REMARKS

Applicant submits the following remarks in response to the Final Office Action of November 18, 2003 ("FOA"). Claims 18 and 21 have been amended, claim 19 has been canceled, and claims 23-27 have been withdrawn.

FIG. 6

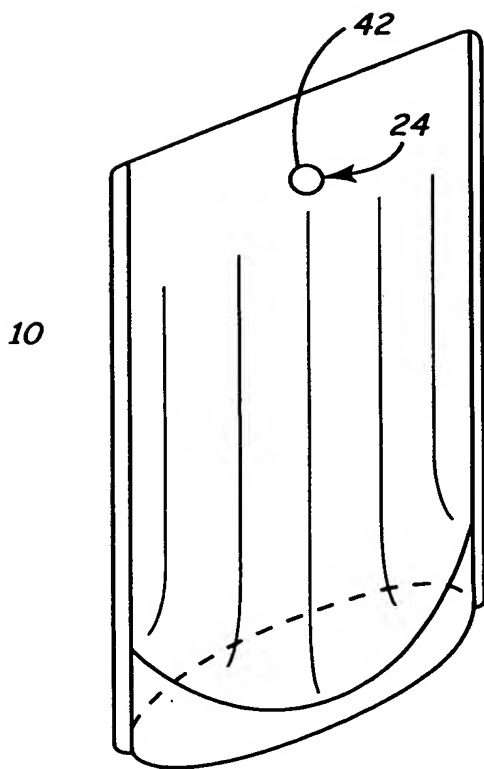
The FOA objected to the drawings for failing to show every feature of the invention specified in the claims. Specifically, the substantially straight line segments joined to each other by the arcuate line segment were not identified in FIG. 6.

Applicant has amended FIG. 6 to identify the first substantially straight line segment 25, the second substantially straight line segment 27, and the arcuate line segment 29 that form the piercing point 24 and hinge 42 illustrated in FIG. 6. No new matter has been added. Applicant respectfully requests that the objection be reconsidered and withdrawn.

Applicant has amended the specification to add further discussion of FIG. 6, which clearly shows that the piercing point 24 and hinge 42 are defined by a single continuous channel that has a first substantially straight line segment 25, a second substantially straight line segment 27, and an arcuate portion or line segment 29. As clearly shown in FIG. 6, the first end of the
